CM-0017-00(041) / 106852301 Desoto County(ies)

MISSISSIPPI DEPARTMENT OF TRANSPORTATION

SECTION 904 - NOTICE TO BIDDERS NO. 5831

SUBJECT: Location & Configuration of Communication Nodes

Layout of Communications HUT

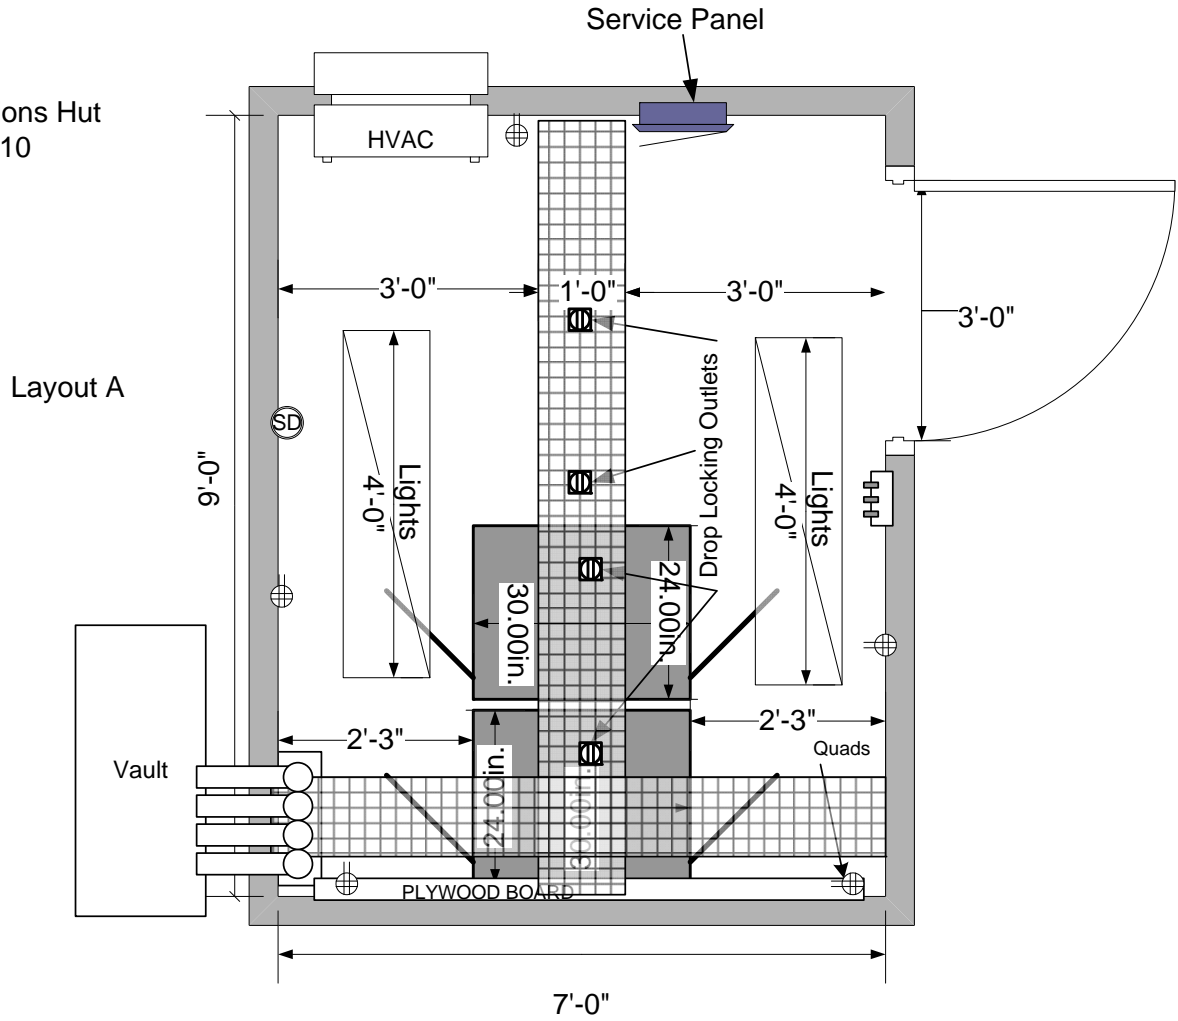
- The Type C Network Switch as specified in special provision 907-658 will be connected by the Contractor in the Hut as follows:
 - The contractor is responsible to mount the Type C network switch in the Contractor provided 19 inch racks at the Communications Node Huts.

- The contractor shall provide fiber optic patch cords at least 6 ft in length. In addition, the contractor shall provide 10 spare fiber optic patch cords per Communication Node Hut.
